Memorandum

Date: June 29, 2018

Re: Expert Panel Review of Version 1.0 of the
Ventura Regional Groundwater Flow Model (VRGWFM)
(Ventura County, California)

Figure 3. Example Calibration Hydrograph for a Well with a Good Match

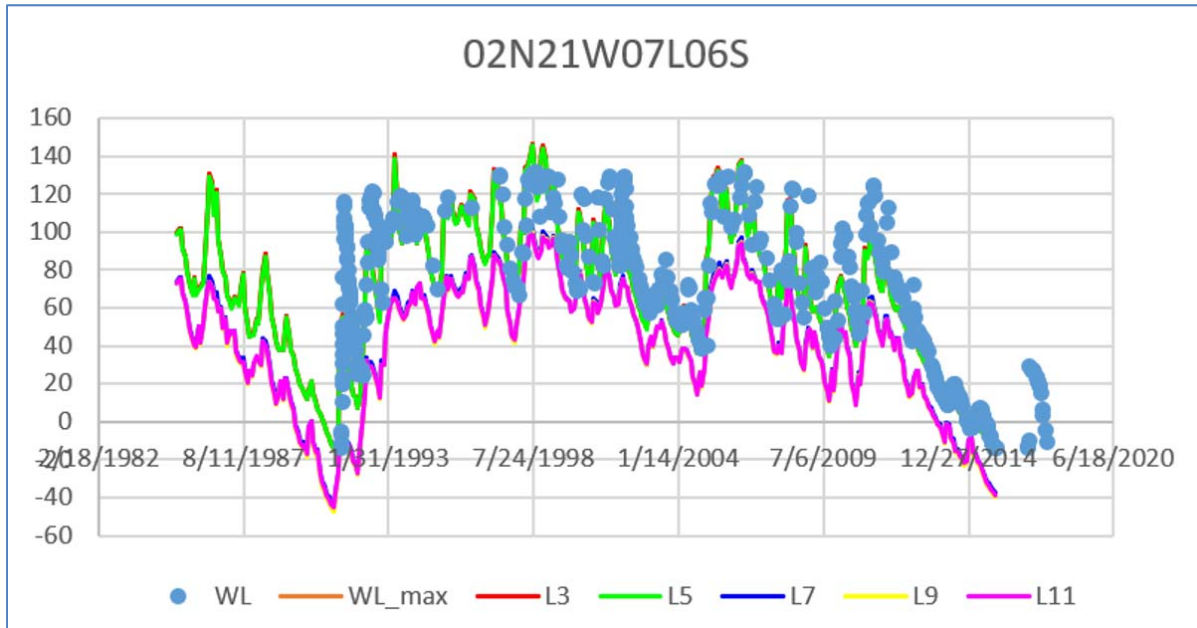
Hydrographs provided by UWCD show field measurements and model-simulated water levels in each layer penetrated by the well. The panel reviewed 270 hydrographs to determine the number of good matches and poor matches. As an example of the visual inspections of each hydrographs, Figure 3 shows a good match while Figure 4 shows a poor match.

Figure 5. Scatter Plot for Groundwater Elevations

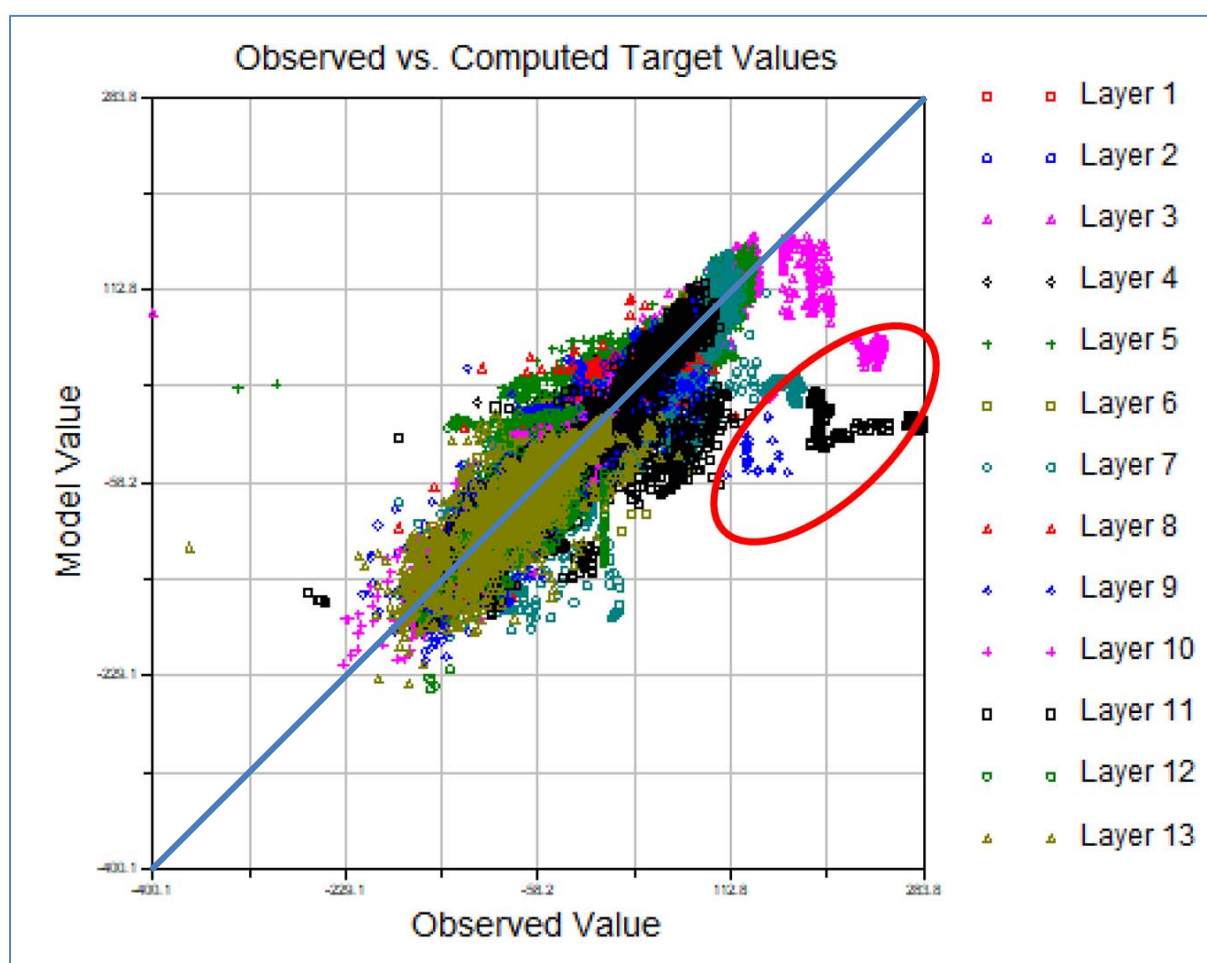
Another visual representation of calibration quality is a scatter plot of observed versus simulated water levels. In an ideal calibration, the values fall on a straight line at a 45 degree angle. The degree of scatter and any bias in the line of best fit provide information on the degree of regional spatial bias. The scatter plot generated by the panel for the water level elevation calibration is shown in Figure 5. Except for some outliers (shown in red ellipse) the degree of scatter about the 45 degree line is good and does not indicate the existence of any significant spatial or temporal bias.

Figure 6. Scatter Plot for Changes in Groundwater Elevations

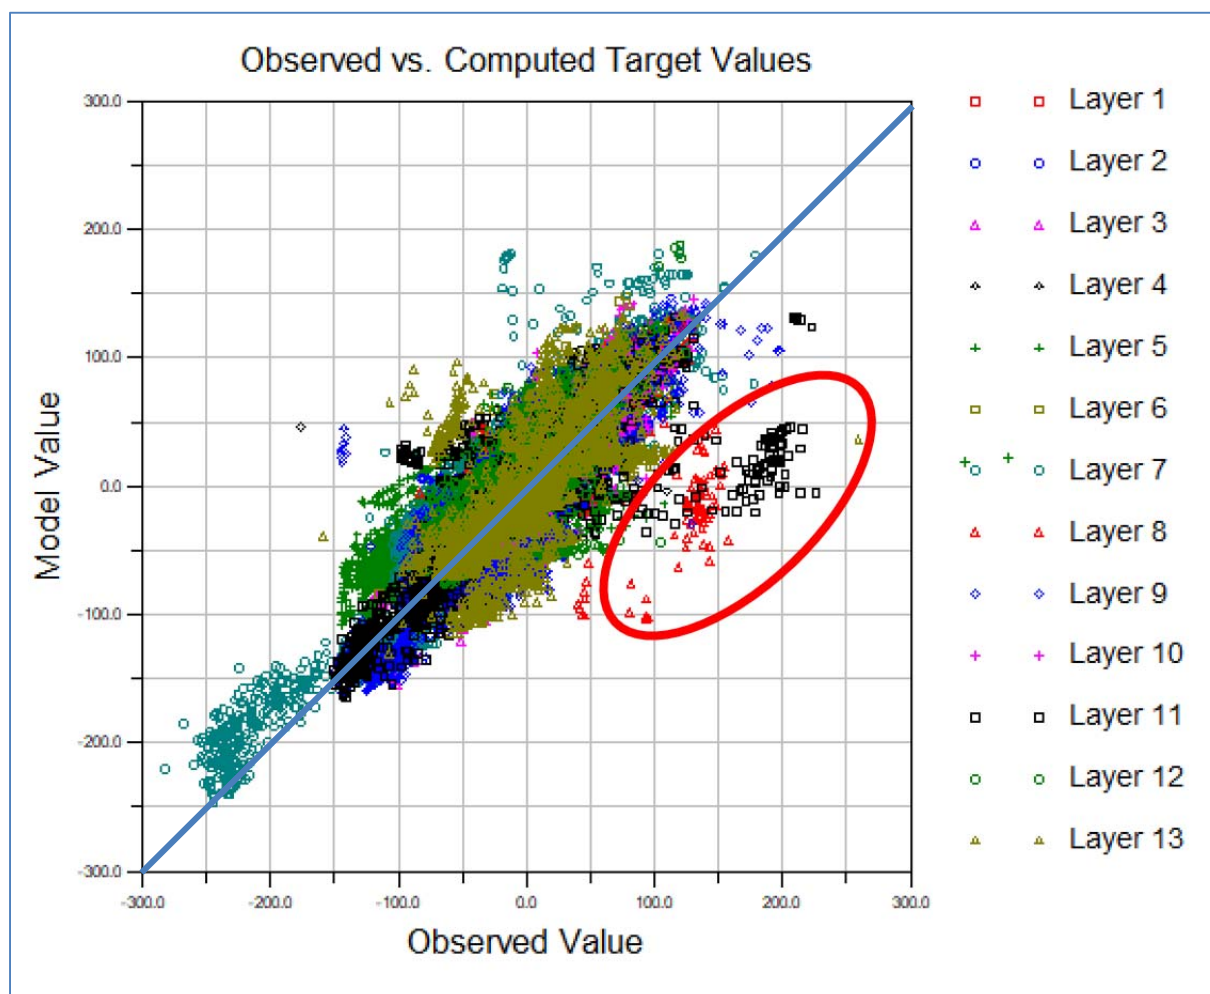
The same sort of scatter plot for change in head is shown in Figure 6. The degree of scatter is similar to that for the elevation match, and again no significant bias is shown.

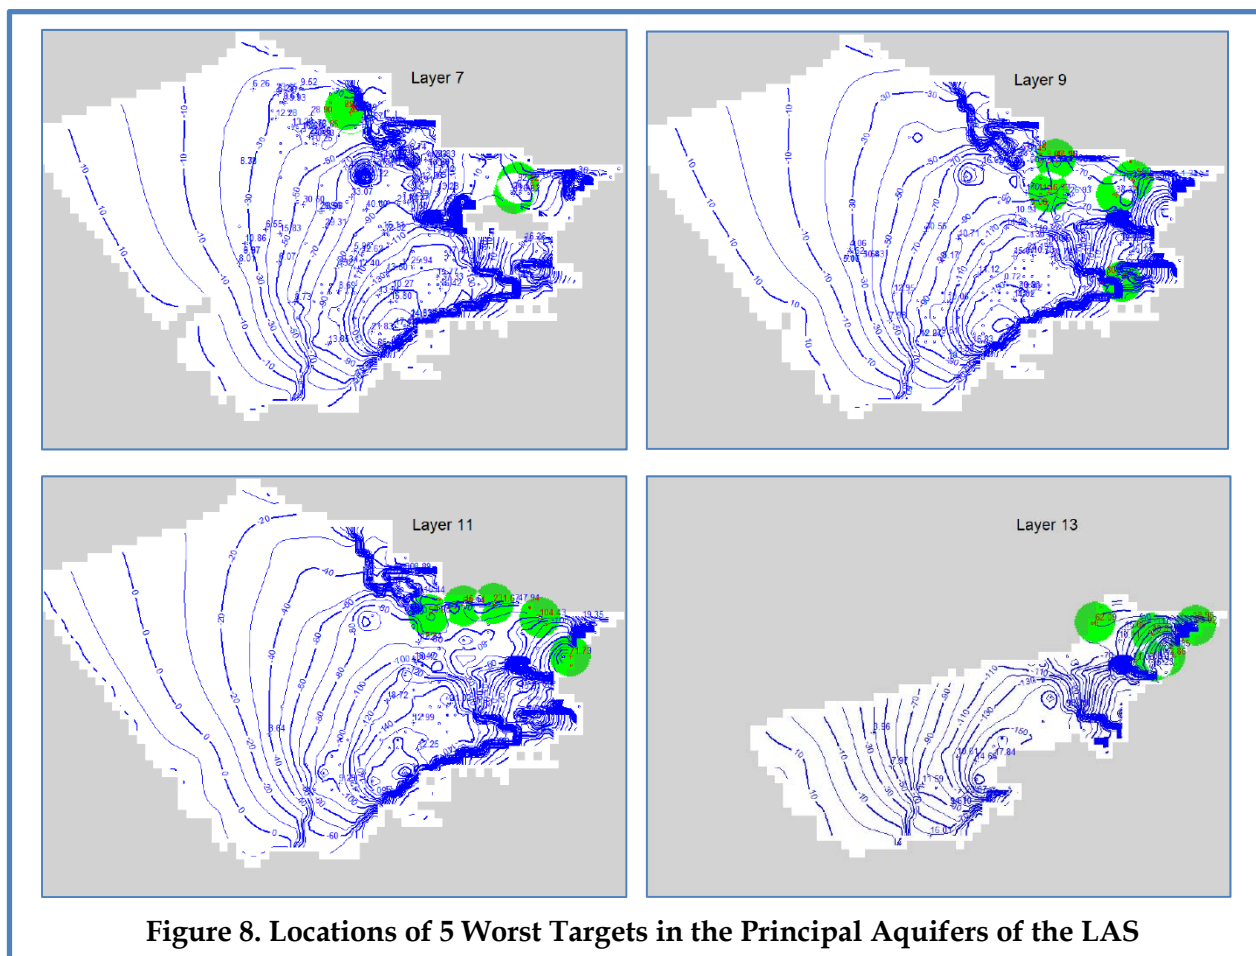
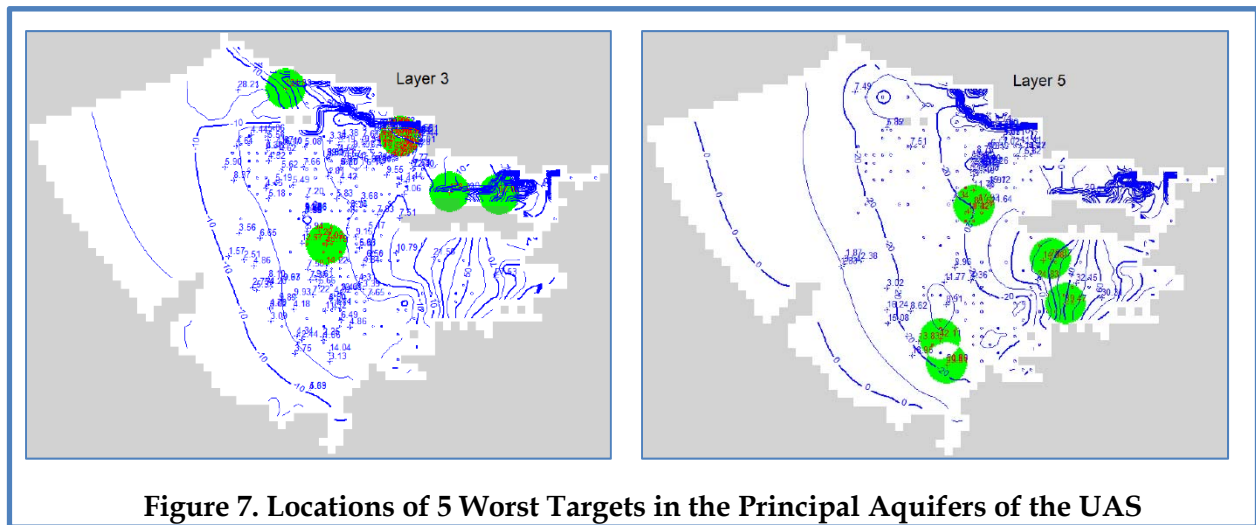
Figure 7 shows maps of the location of the worst matches in two model layers in the UAS (the Oxnard Aquifer in layer 3, and the Mugu Aquifer in layer 5). Each map uses green dots to show the locations of the five worst hydrographs in a given model layer. Figure 8 shows similar maps for the four principal aquifers in the LAS (the Hueneme Aquifer in layer 7, the Fox Canyon Aquifer's upper and basal units in layers 9 and 11, and the Grimes Canyon Aquifer in layer 13). Together, these maps provide an understanding of the spatial distribution of error by allowing for identification of the existence (or lack thereof) of spatial bias in the locations of poorly matched wells. As shown by these figures, the worst hydrographs tend to lie (1) on or near the outer boundaries of the model, where groundwater gradients are steep due to topography, faulting, and/or significant rates of recharge, and (2) at locations inside the model domain where hydraulic gradients are steep because of groundwater pumping. The occurrence of the largest errors in places with steep gradients is not surprising, given that groundwater elevations may differ by tens to hundreds of feet between the 2,000-foot wide model grid cell containing the green dot and one or more of its neighboring grid cells of equal size. The use of refined grid spacing in future applications of the model likely would cause simulated groundwater elevations (and changes in elevations) to more closely match observed conditions; accordingly,

adjustments to hydraulic parameters in the model are not warranted in these areas without first conducting further testing and evaluation using refined grids.
